FINAL ENVIRONMENTAL ASSESSMENT

***KAPIOLANI REGIONAL PARK  
MASTER PLAN UPDATE***

Waikiki, District of Honolulu, O'ahu, Hawai'i

April 2008

FIGURE 16  
ALTERNATIVE 'D'

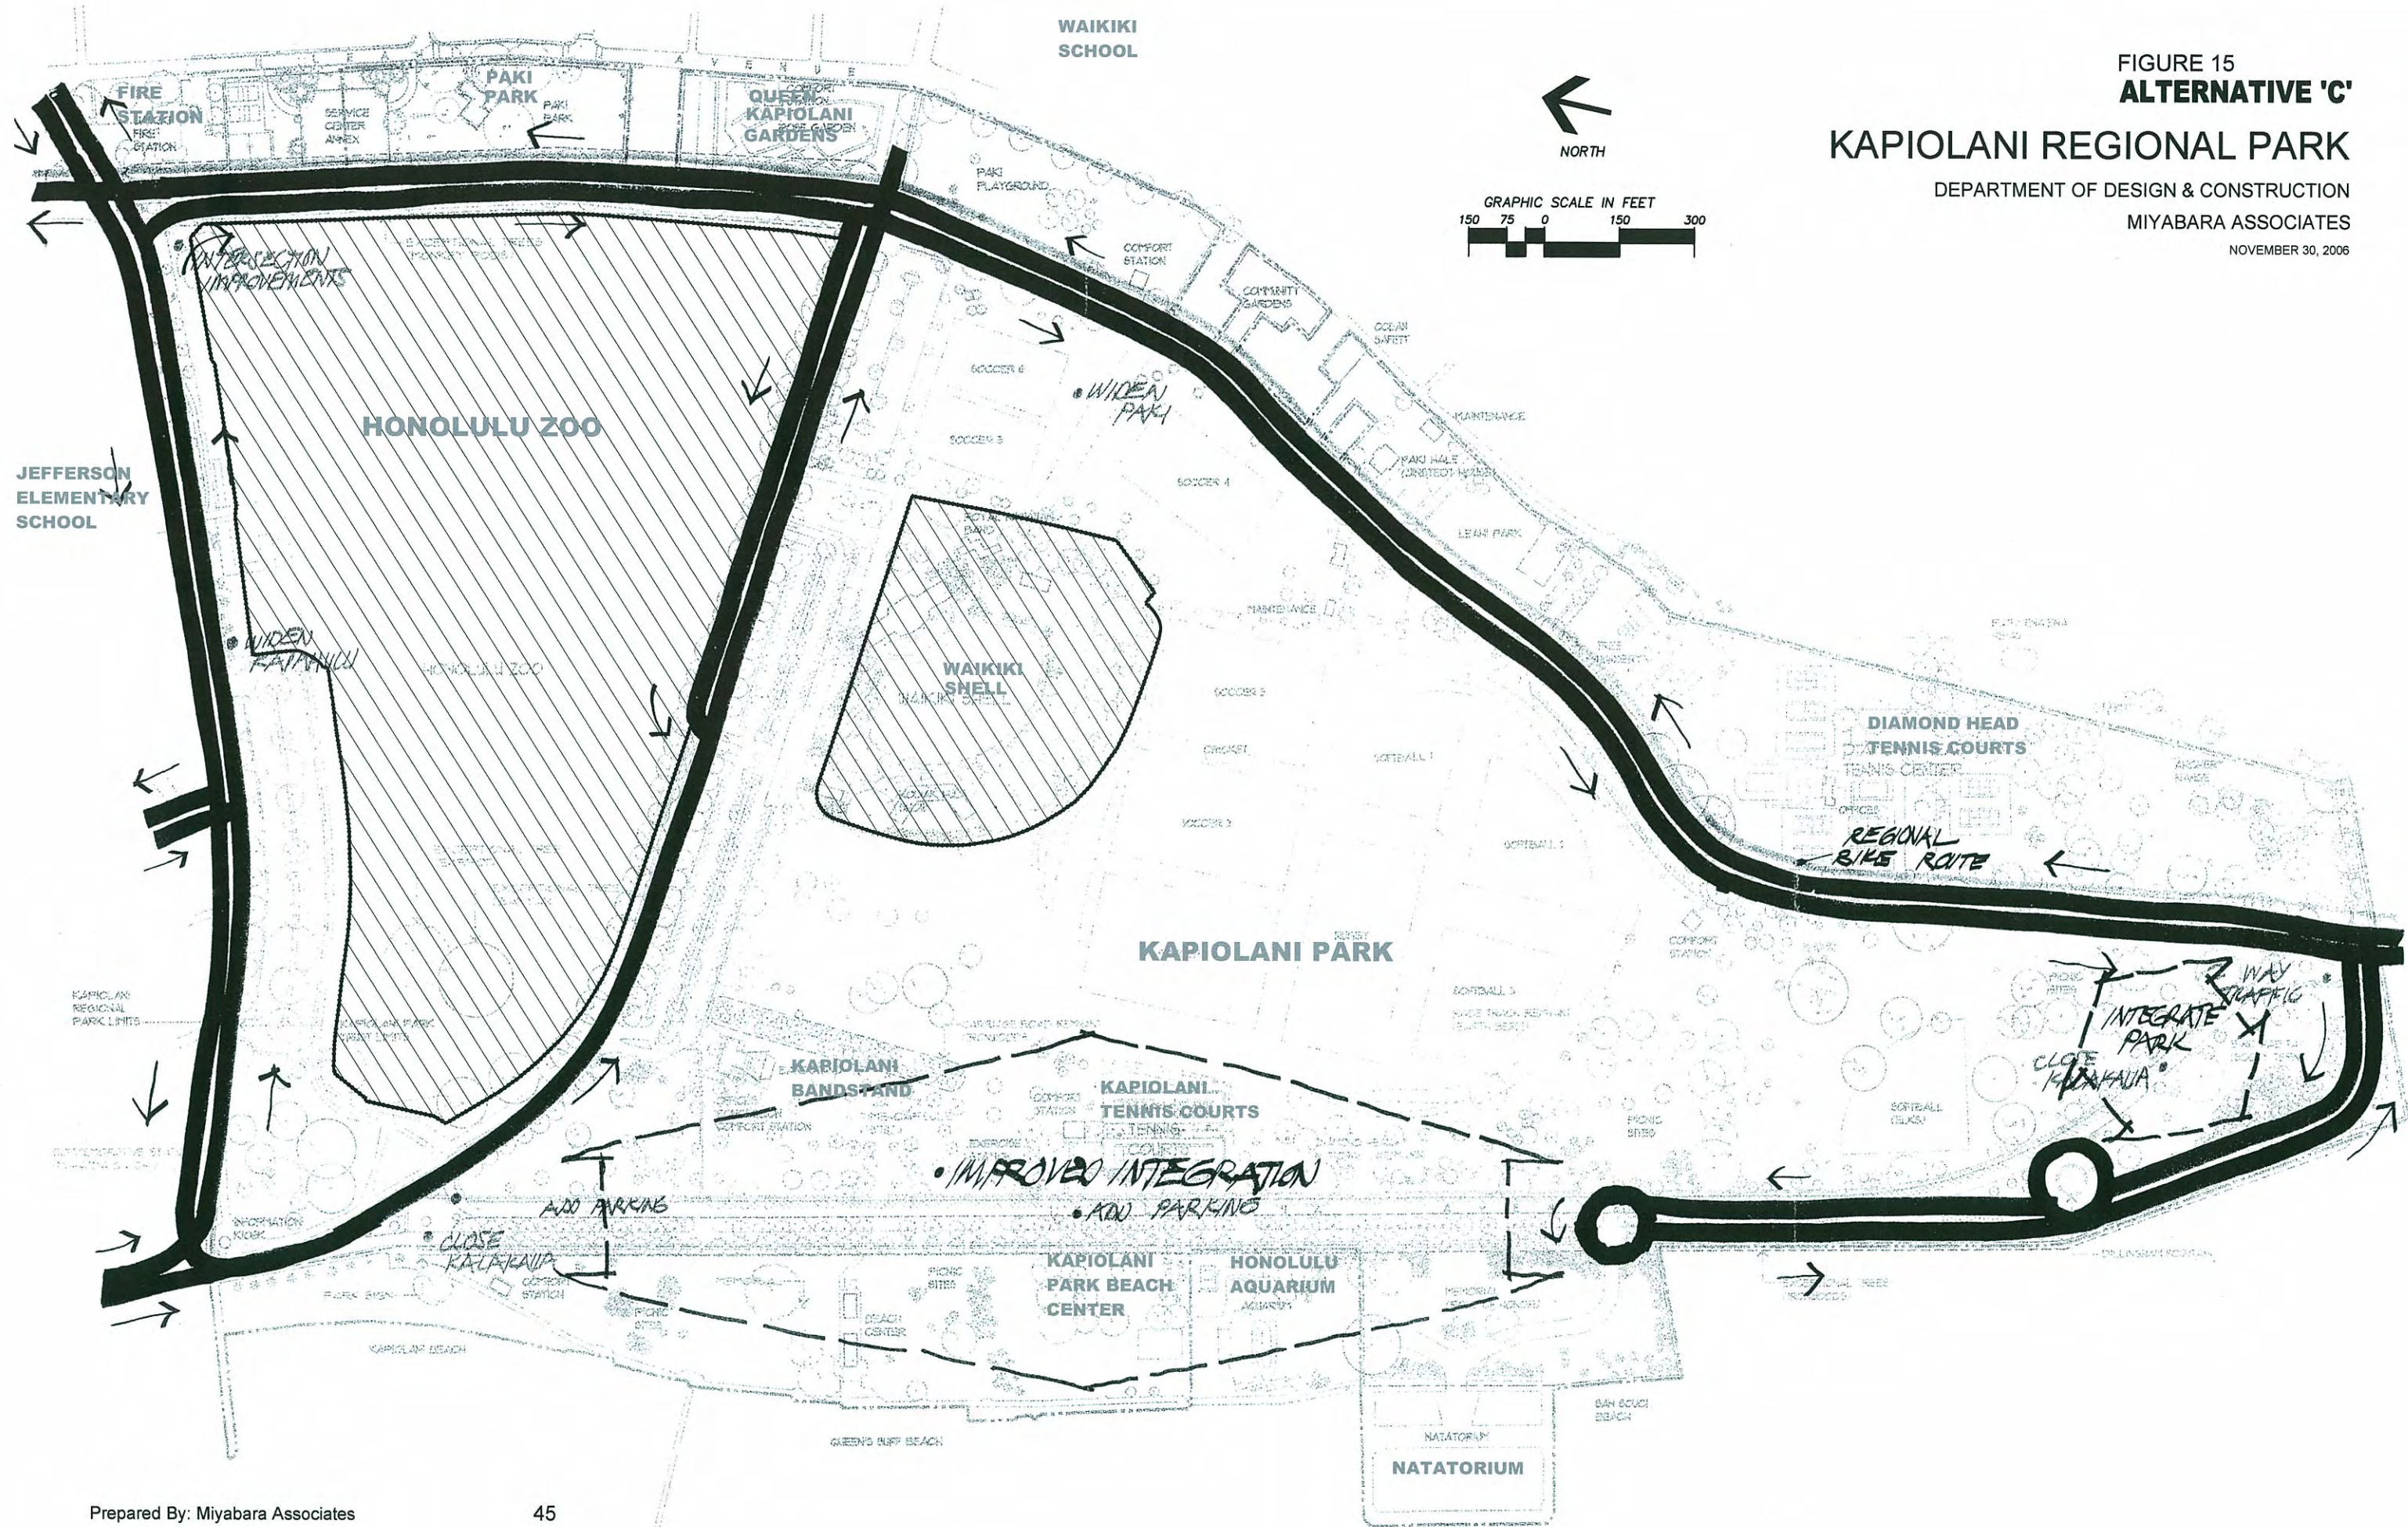
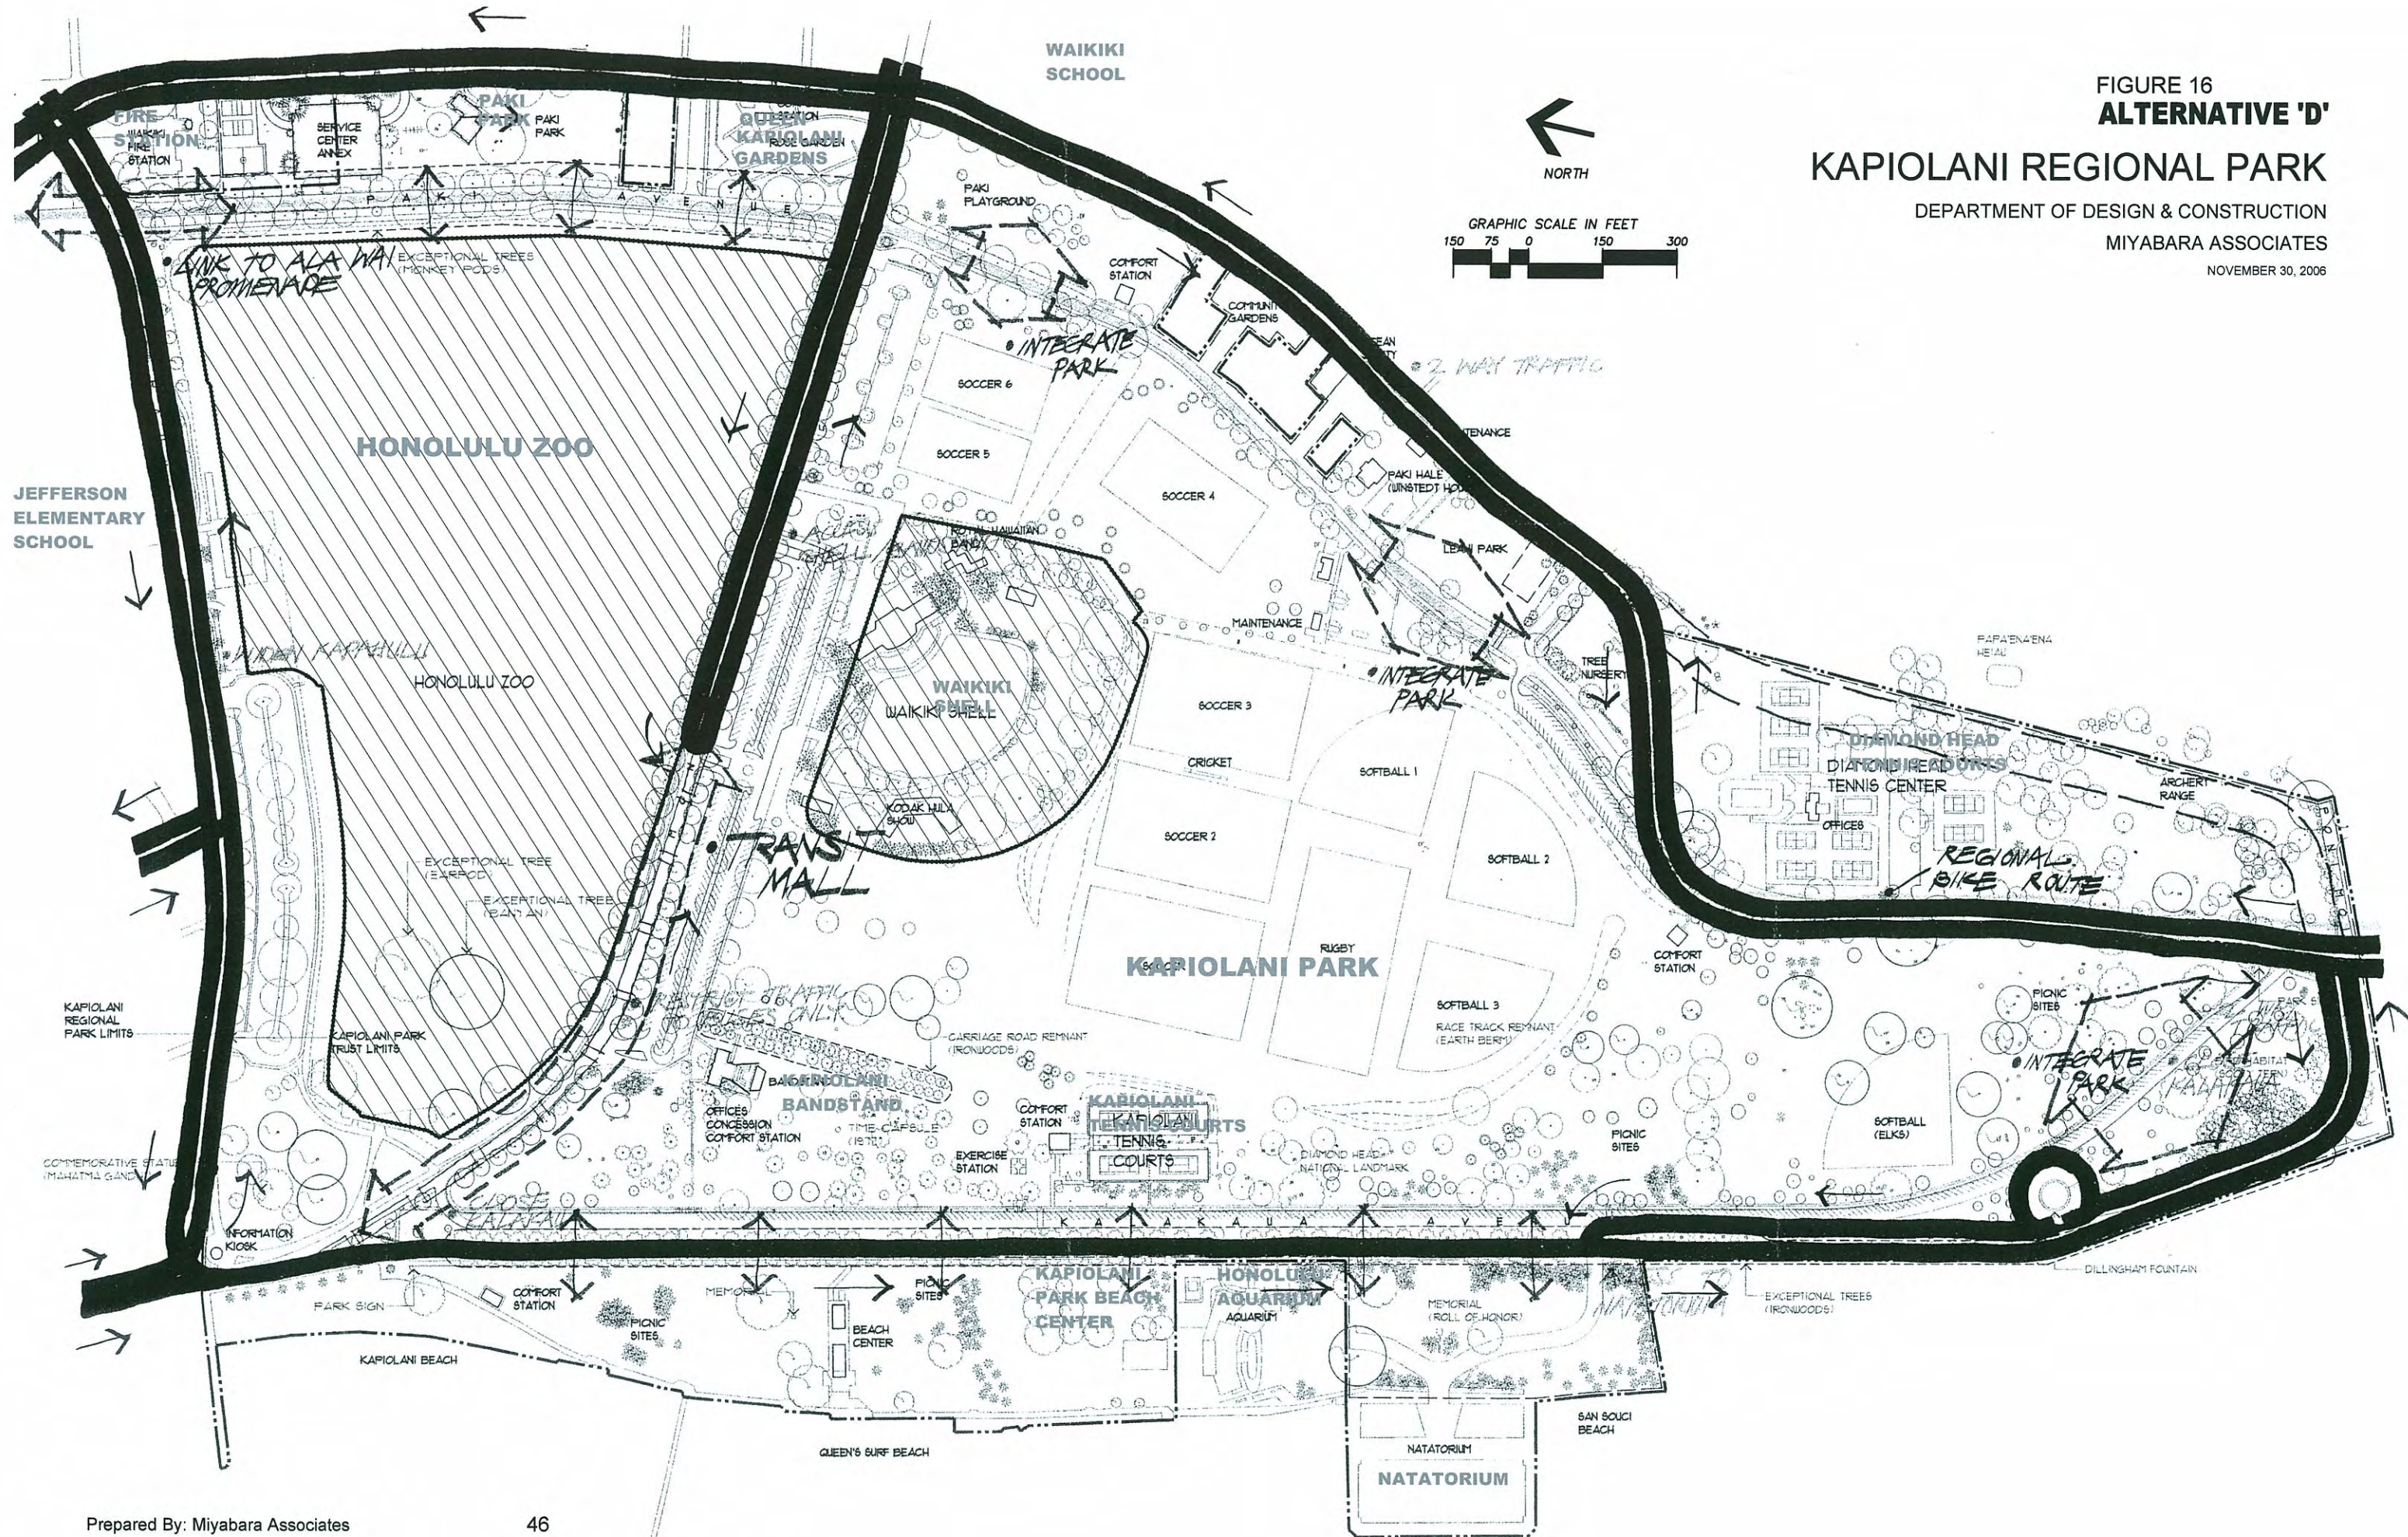
**Keep the Park's traffic circulation pattern as it is. Alternative plans A - D (fig 13-16) are unacceptable and alter the historic character of the Park.**

Circulation Alternatives "A" thru "D" were not selected for implementation in the Kapiolani Regional Park Master Plan Update because changes in existing circulation patterns could affect vehicle circulation beyond the limits of the Park in neighborhoods such as Waikiki, Kapahulu, and Diamond Head. Changes to the existing circulation pattern also would affect bus routes and bus stops on streets in the vicinity of the Park.
